MODIF EXPORT SUPERSTAR 3900 EFT

Modif export en image du SS 3900 EFT

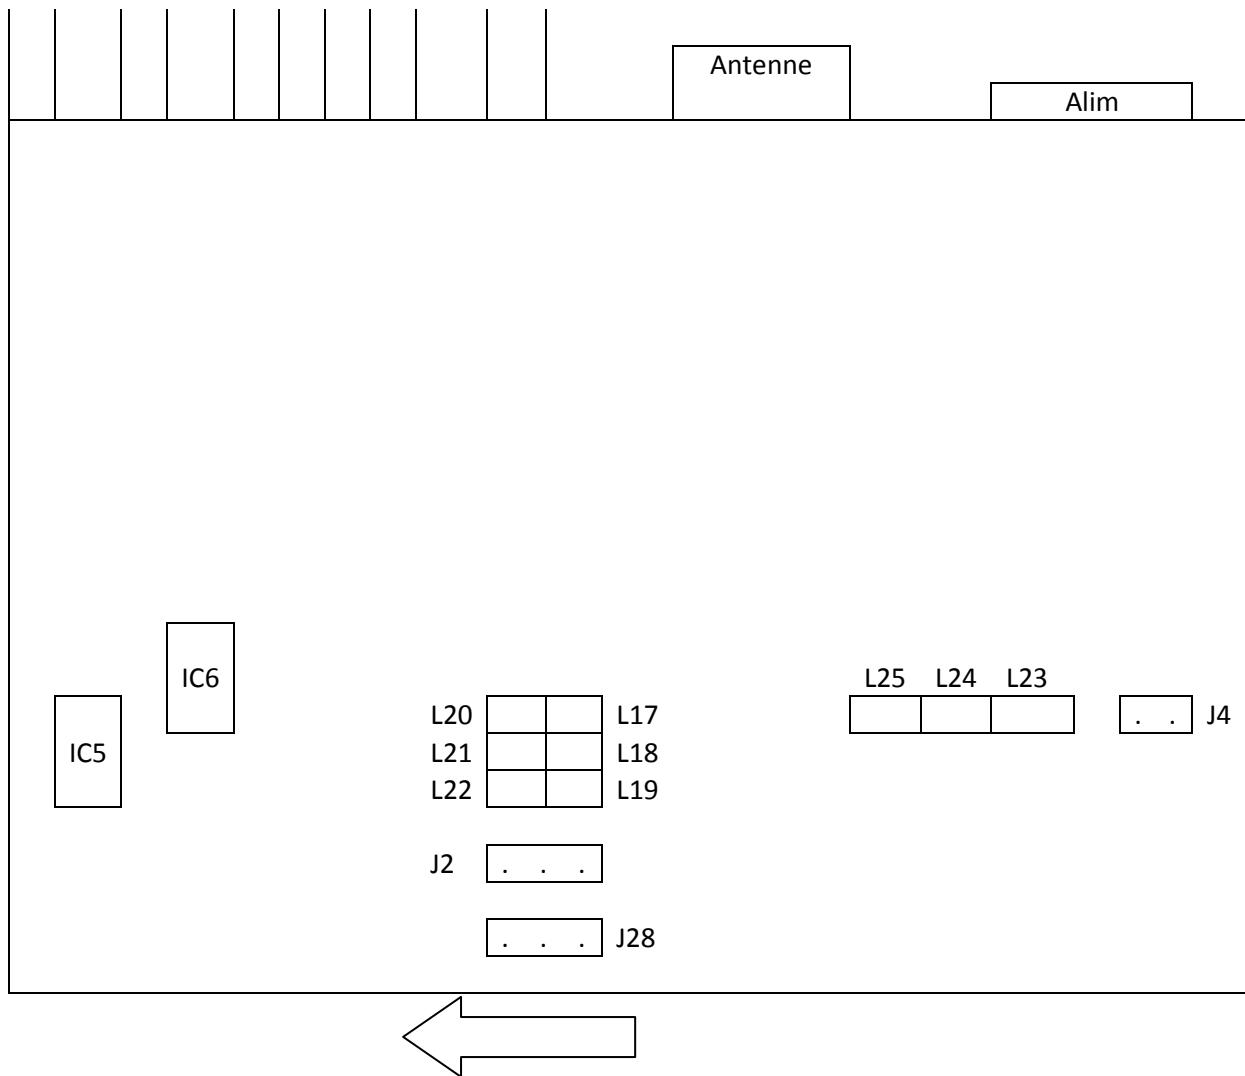
MOVE THE STRAP **J28** OF A NOTCH IN THE SENSE OF THE ARROW

MOVE THE CONNECTOR **J4** ON THE CONNECTOR **J2**

DELETE THE WELDED RESISTANCE ON **IC5** (weld side)

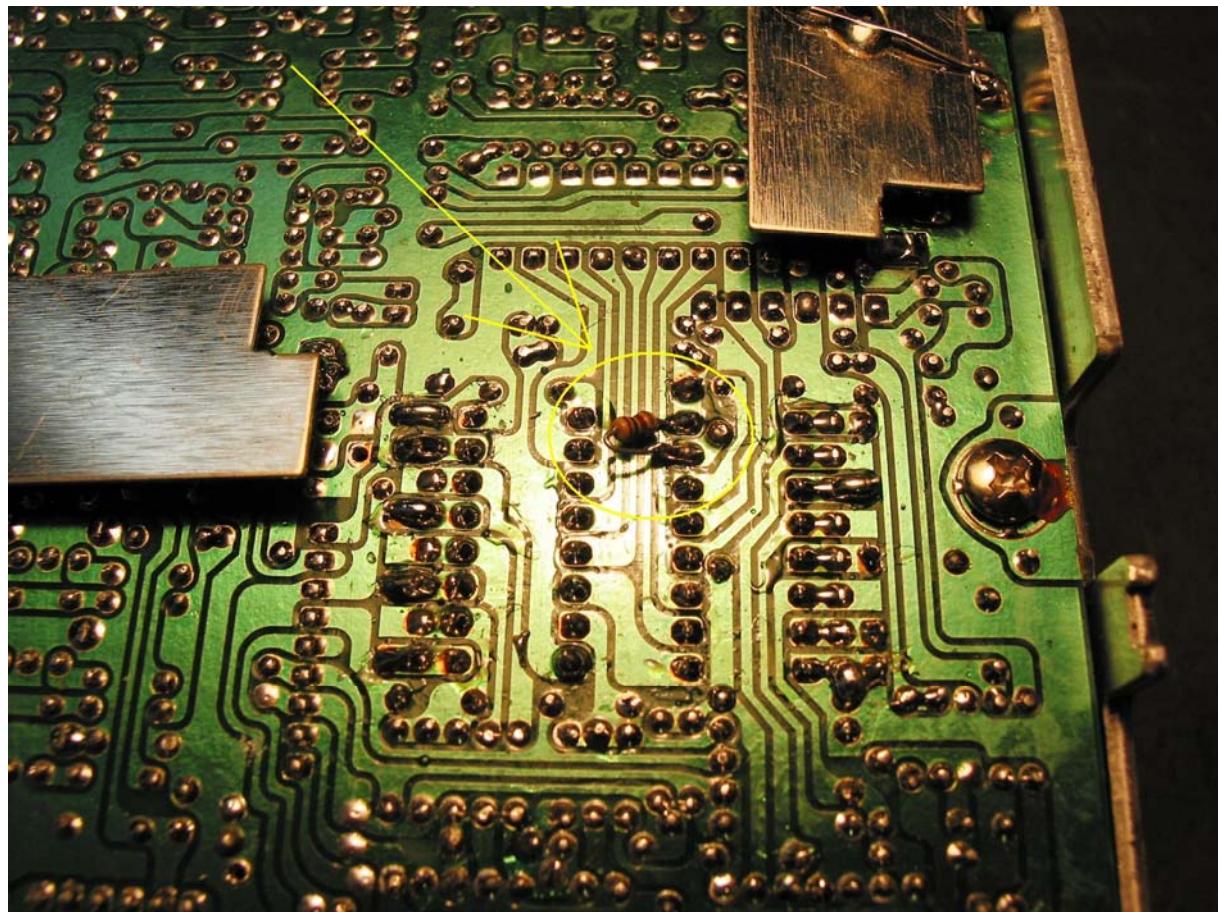
Démonter les 2 capots et retirer la résistance côté soudures

DELETE THE WELDED RESISTANCE ON **IC5** (weld side)

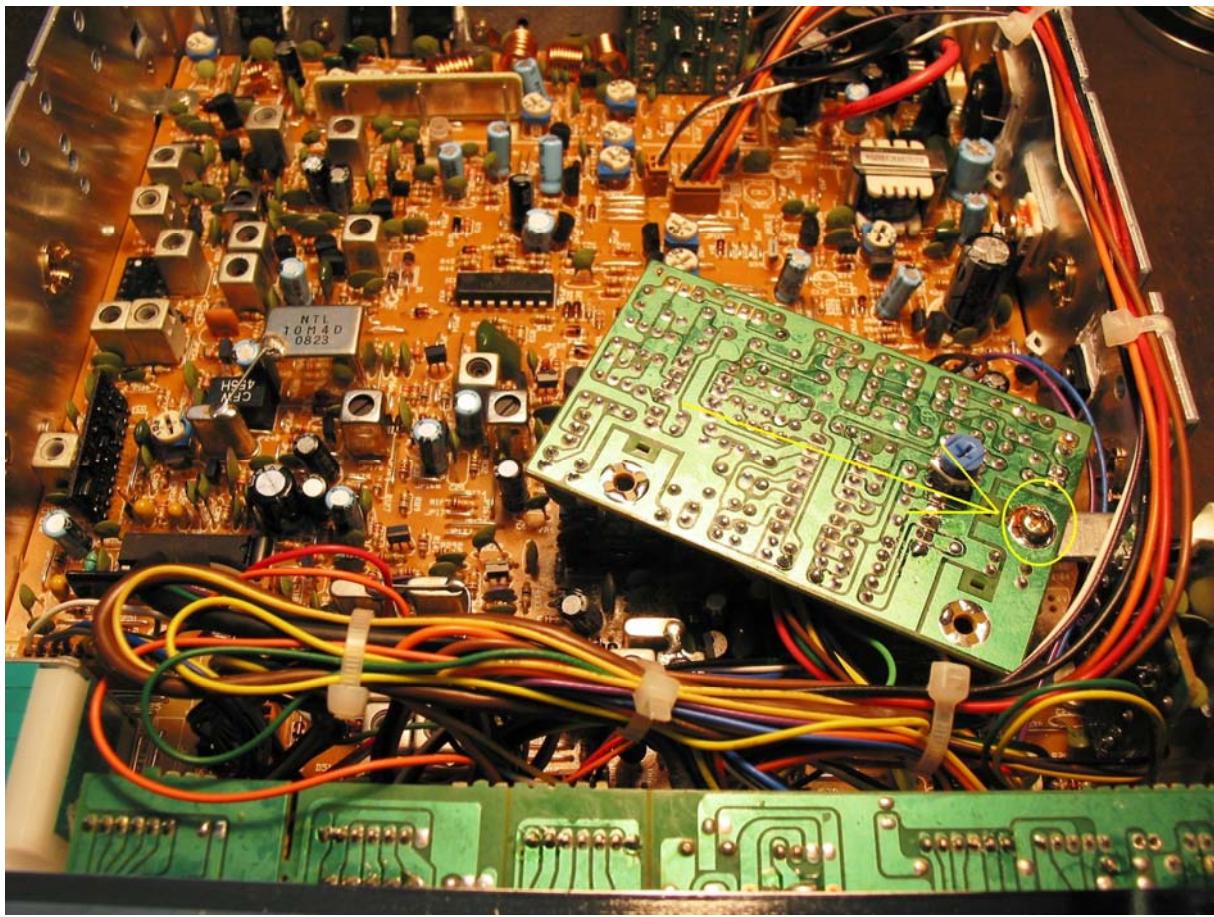
Coté composant démonter la vis de la platine écho

Take down the screw on the echo board

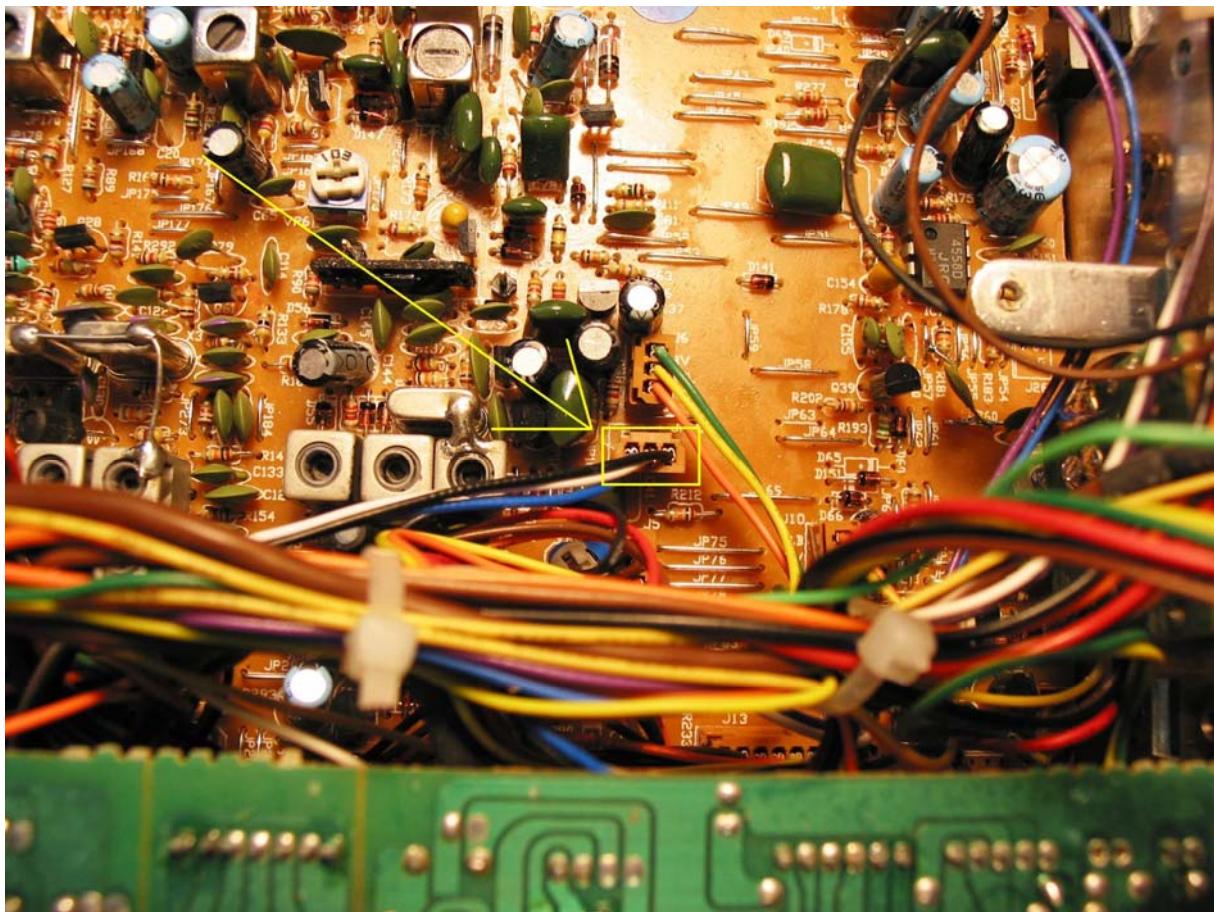
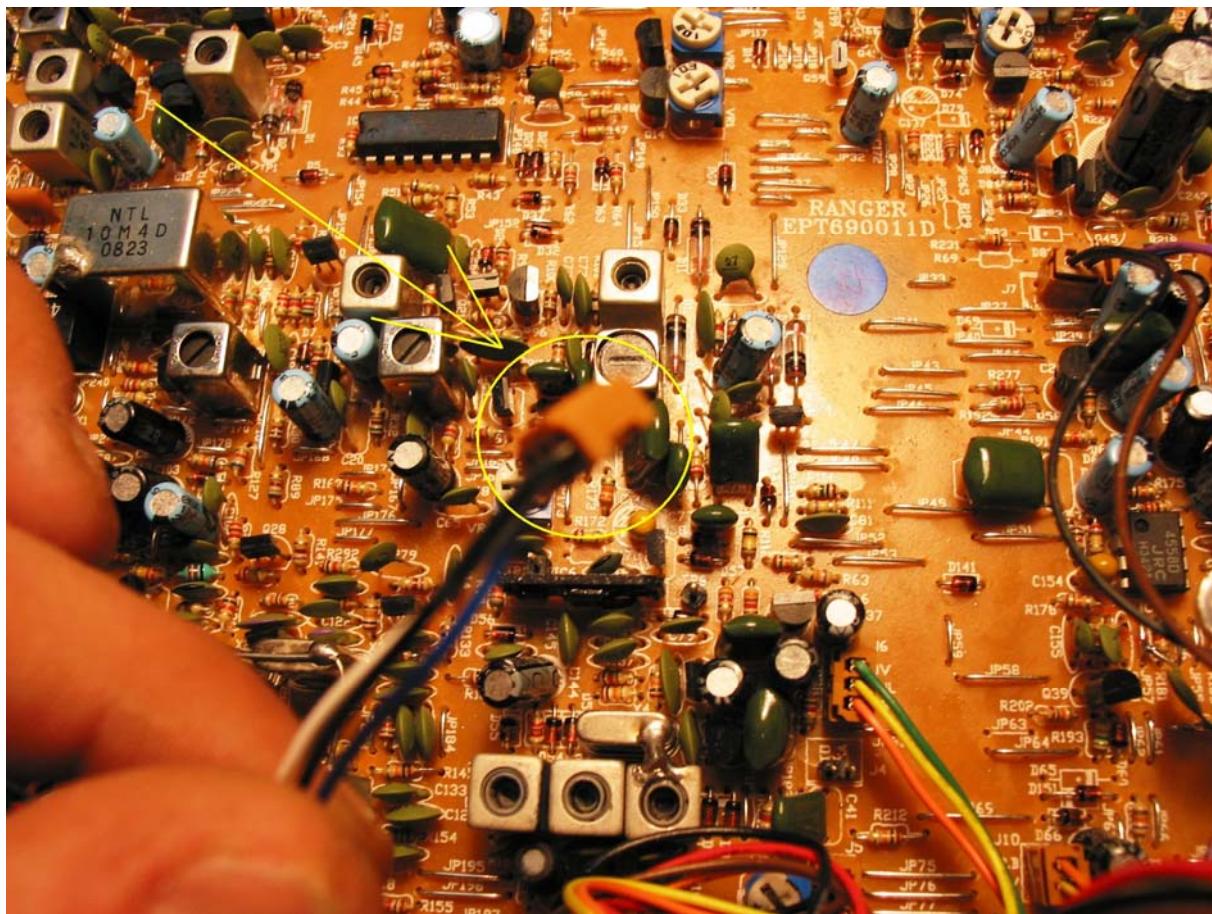
-Voici le fil qui est branché sur J4 et qui faut brancher sur J2

- You can move the echo board to reach the wire which is on J4 : disconnect the wire on J4

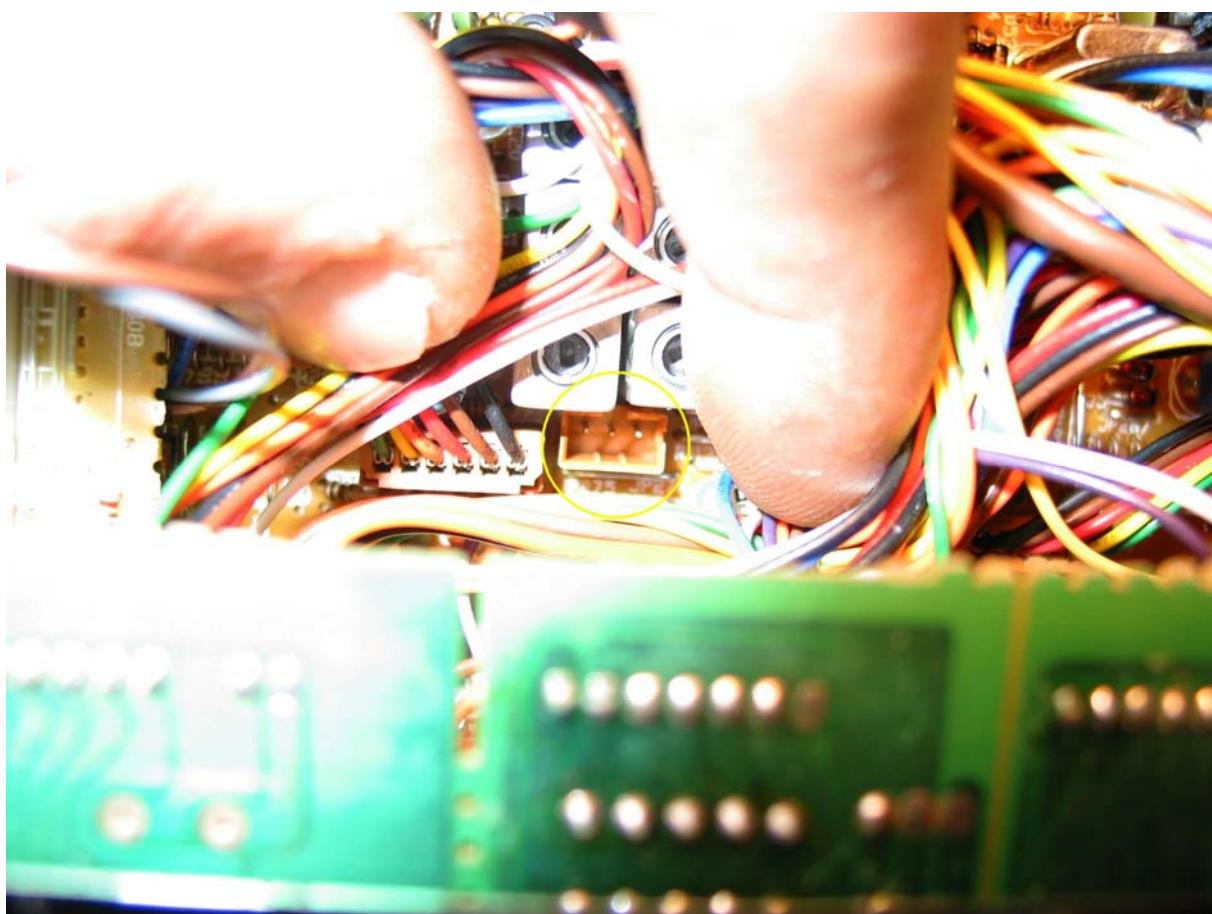
Rechercher au milieu des fils le connecteur J2

Look for the connector J2 in the middel of the wires

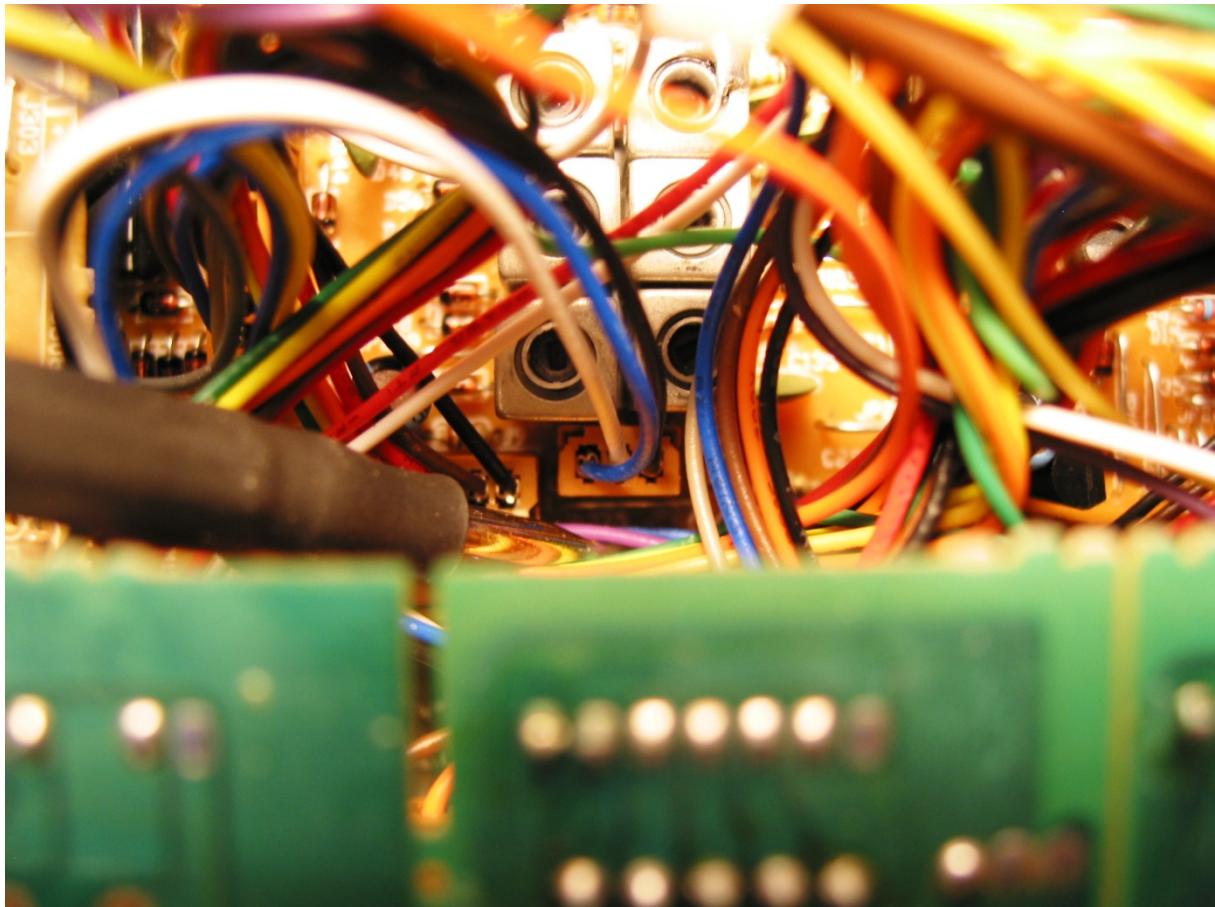
- brancher le fil J4 sur le connecteur J2
- CONNECT the wire J4 on the connector J2

- Déplacer vers la droite le cavalier de configuration

- MOVE THE STRAP **J28** on the right
